## Silicon identification

This errata sheet applies to the M24256-BR and M24256-DF, which are 256 Kbit serial I<sup>2</sup>C bus EEPROMs, and specifically to the devices delivered in 8-bump wafer-level chip-scale packages (WLCSP).

Figure 2. D and E front side view

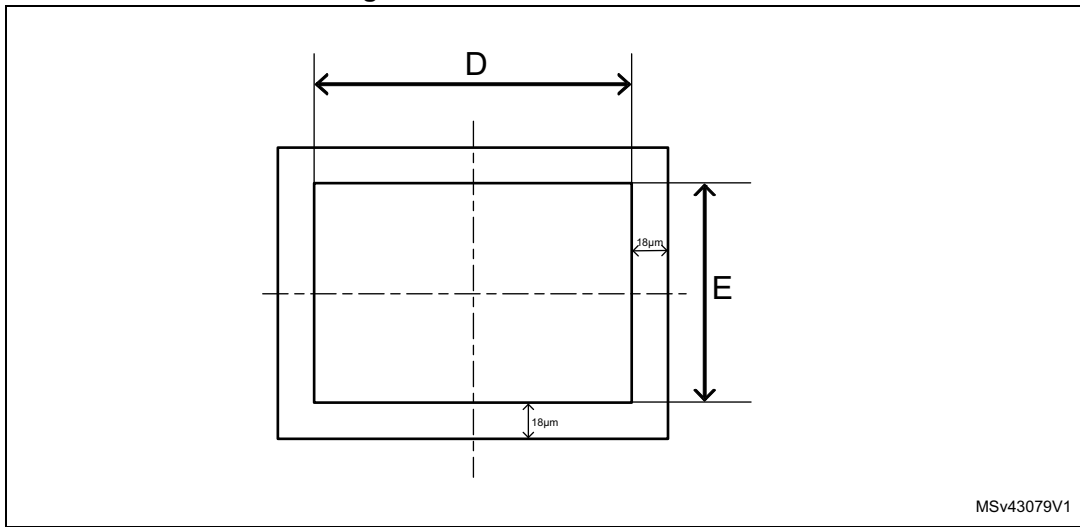
- The D and E values in the M24256-BR/M24256-DF datasheet correspond to front side view (ball side), instead of back side view (marking side view).  
[Table 2](#) and [Table 3](#) report the data for the front and back view, respectively.

Symbol	Millimeters			Inches		
	Min	Typ	Max	Min	Typ	Max
D	-	1.271	1.291	-	0.0500	0.0508
E	-	1.358	1.378	-	0.0535	0.0543

Figure 3. D and E back side view

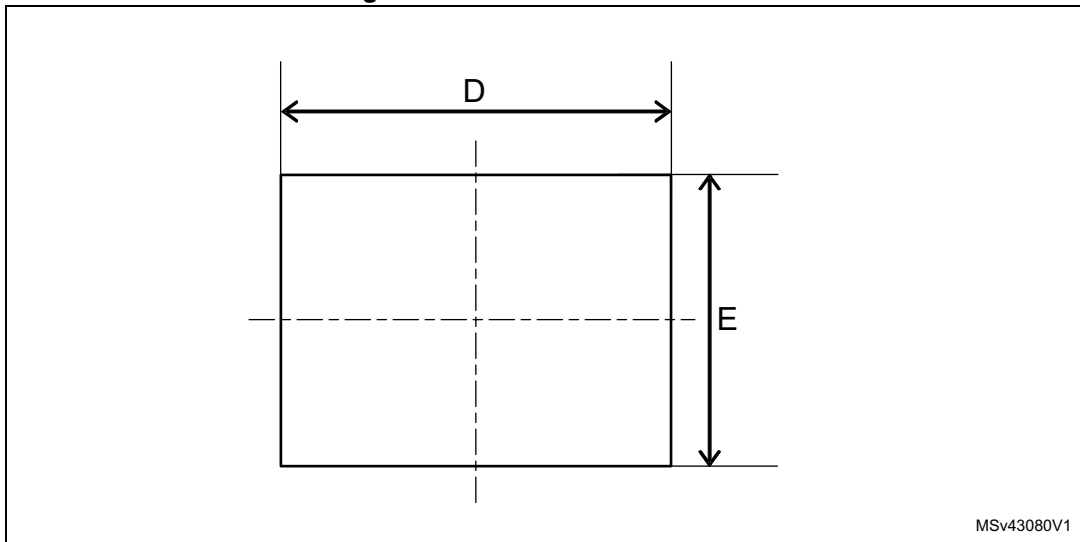
This document refers to the changes in dimensions D and E (see [Figure 3](#)) described in the M24256-BR/M24256-DF datasheet, in tables detailing the dimensions of the WLCSP 8-bump package.

D and E values must be modified to correct the following mistake:

Symbol	Millimeters			Inches		
	Min	Typ	Max	Min	Typ	Max
D	-	1.289	1.309	-	0.0507	0.0515
E	-	1.376	1.396	-	0.0542	0.0550

Figure 4. D or E side view

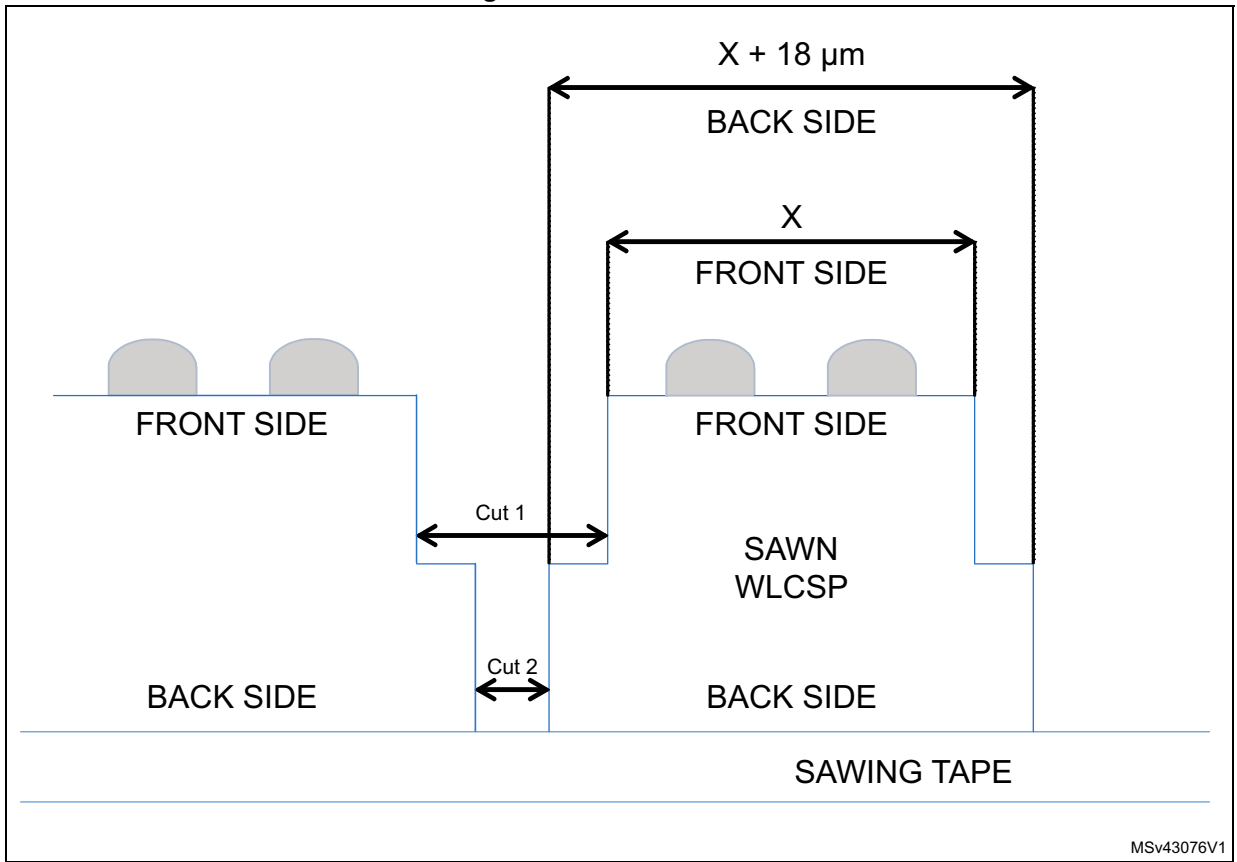
The difference between back side and front side dimension is 18 µm (0.018 mm). This difference is due to the two-step sawing process, where cut 1 and cut 2 are performed with blades having different thicknesses (see [Figure 4](#) in which X represents D or E and it has the same value and tolerance).
